**PROCELTEK**  
 Prestressed Concrete Solutions

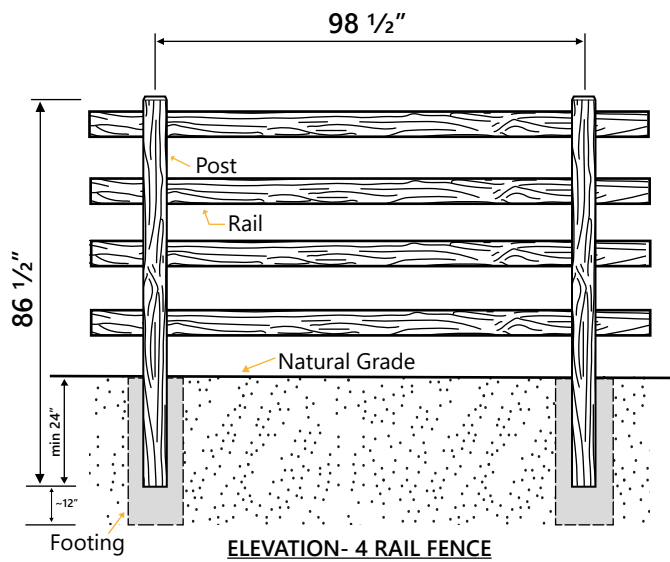
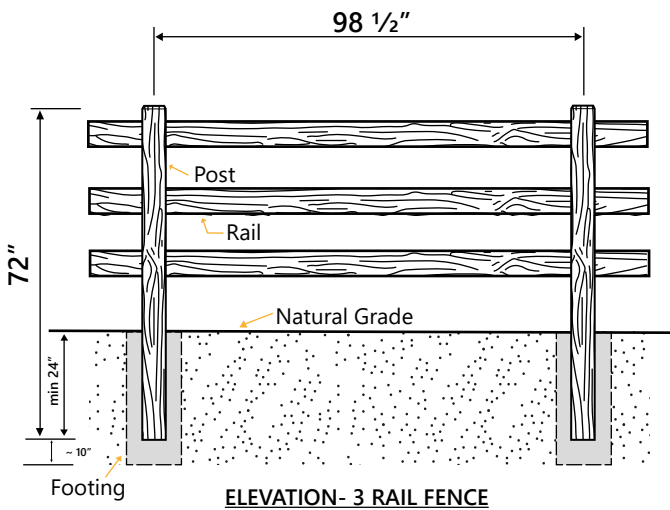
The concrete panel need to be at least 1 1/16" inside the post on each side.
